APPLICATION NUMBER: RECON 24/0862

PROPOSAL: PROPOSED NEW SHOP FRONT, CONVERSION OF FIRST FLOOR OFFICES AND ROOF SPACES TO CREATE 5 NO. FLATS, CONVERSION OF PART GROUND FLOOR TO PROVIDE A CLASS A3 UNIT, CAR PARK ALTERATIONS AND ASSOCIATED WORKS

SITE: 170 - 172 Commercial Road Newport NP202PL

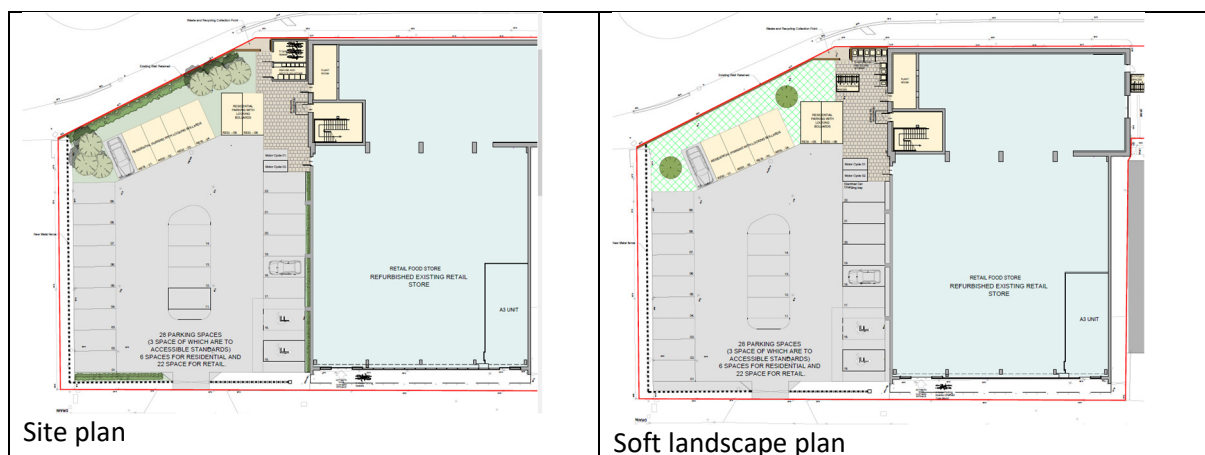
The RECON provides a soft landscape plan below right which differs significantly from the Site Plan below left.

The soft landscape proposal comprises 2 small nursery stock birch set in meadow, the latter is not consistent with the location and overall a more robust soft landscape scheme is required, provided by a landscape professional. The submitted soft landscape plan is not acceptable but could be conditioned.

As the site plan does not reflect the soft landscape plan, at this planning stage the applicant should confirm whether the site plan does or does not accurately show soft landscape opportunities. A narrative would be required to explain any change from the submitted site plan.

The following documents are required and could be conditioned:

1. A detailed soft landscape plan is required, **produced by a professional landscape architect**, to show plant species, size, density, tree pit detail with adequate rooting volume for the species selected. In addition an outline specification for creation of planting beds is required given the existing hard surfacing, this is to include reference to BS8601:2013 for subsoil and BS3882:2015 for topsoil with soil supply professionally tested and recommendations implemented to ensure successful establishment of planting.
2. A five year soft landscape maintenance plan.
